City of Avondale Estates
Planning Architectural Zoning Board
Staff Review, Variances *

November 17, 2025, PAZB Meeting

Applicant: 278 Oak Holdings LLC: Jetha Wagner, Avila Development

Property Address: 136 Laredo Drive, 2968 Parry Street, 147 Oak Street, 2950 Franklin Street, and 2556 Franklin Street (Oak Parcel)

F)

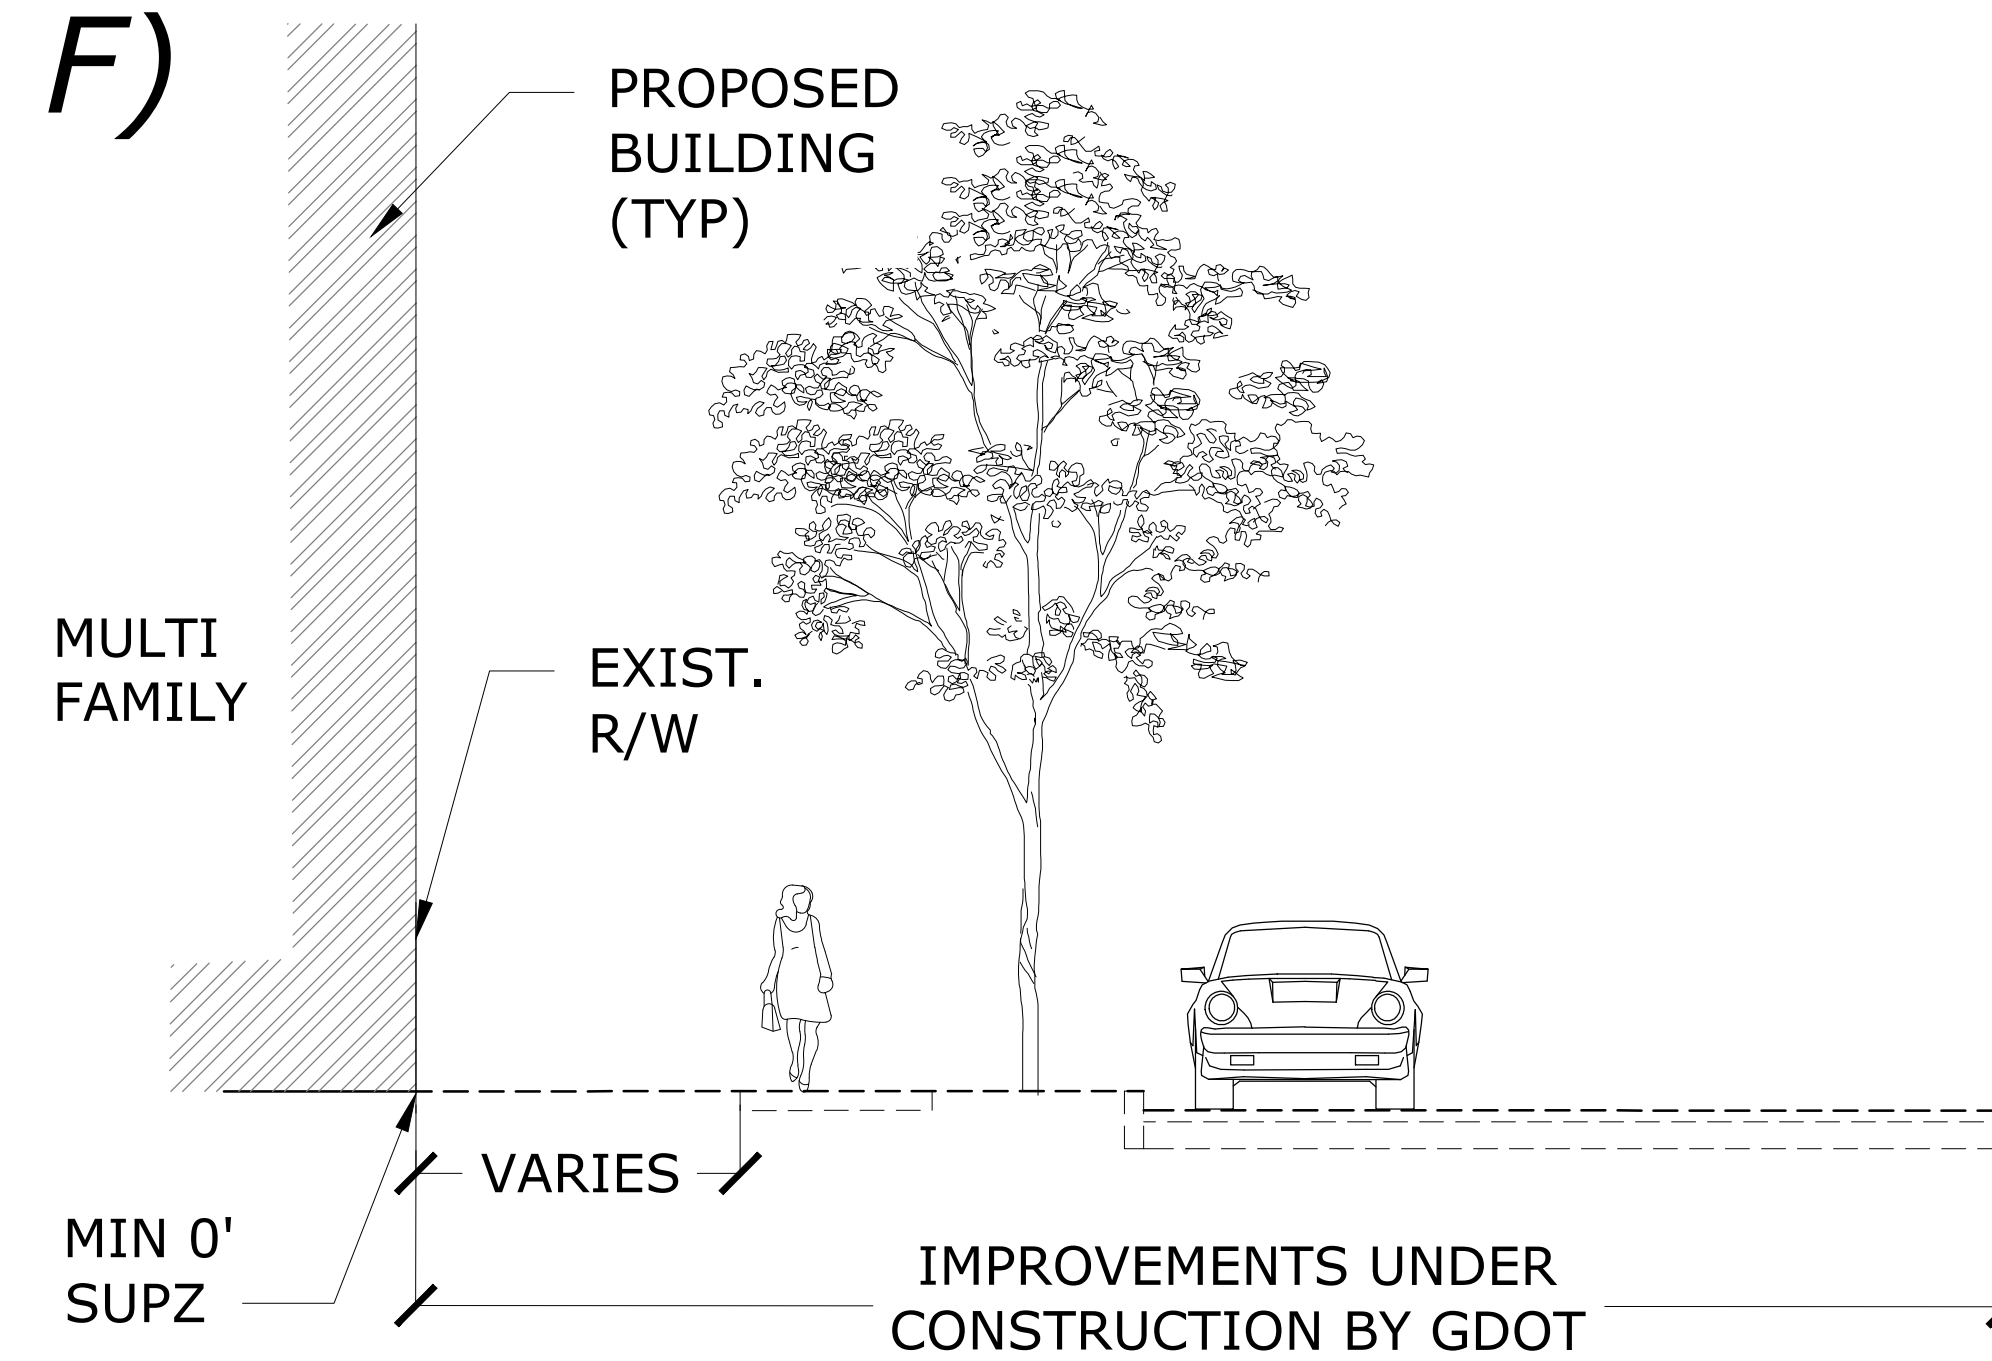
FROM: Figure 21-3.2.8.B.4.d and Table 3.2.8.E reduce type D street section from 40' ROW and 5' SUPZ to building face.

FROM: Figure 21-3.2.8.B.4.c and Table 3.2.8.E reduce type C3 street section from 40' ROW, 2' additional LSZ and 5' SUPZ to building face.

FROM: Figure 21-3.2.8.B.4.c and Table 3.2.8.E realign type C3 street section from 40' ROW, 2' additional LSZ and 5' SUPZ to building face.

FROM: Figure 21-3.2.8.B.4.d and Table 3.2.8.E reduce type D street section from 40' ROW and 5' SUPZ to building face.

FROM: Figure 21-3.2.8.B.4.c and Table 3.2.8.E reduce type C2 street section from 40' ROW, 5' SWZ, and 5' SUPZ to building face.

Figure 3.2.12.F - Transitional Height Plane

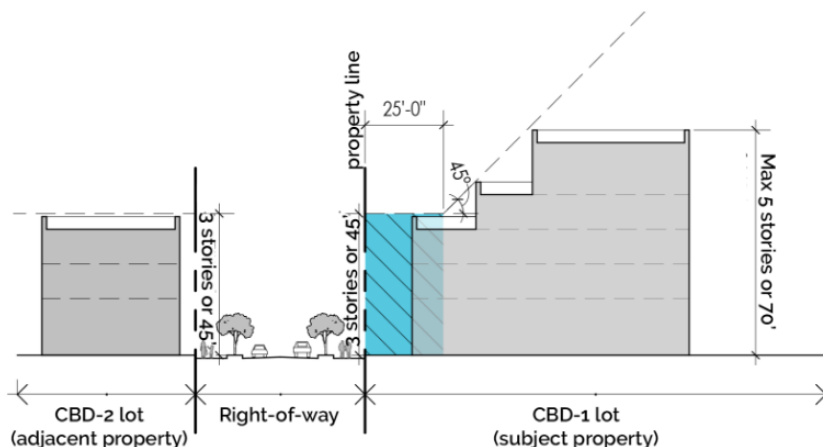
DESIGN TEAM NOTE: This requirement impacts the Southeastern corner of the Maple Street site, which abuts the CBD-2 district across Olive Street. This would limit that portion of the building to 3-stories (instead of 5) which could eventually step up to 5-stories. See Figure 3.2.12.F below. Need to be allowed 5-stories (plus basement) in all locations – including areas where transitional height plan comes into play.
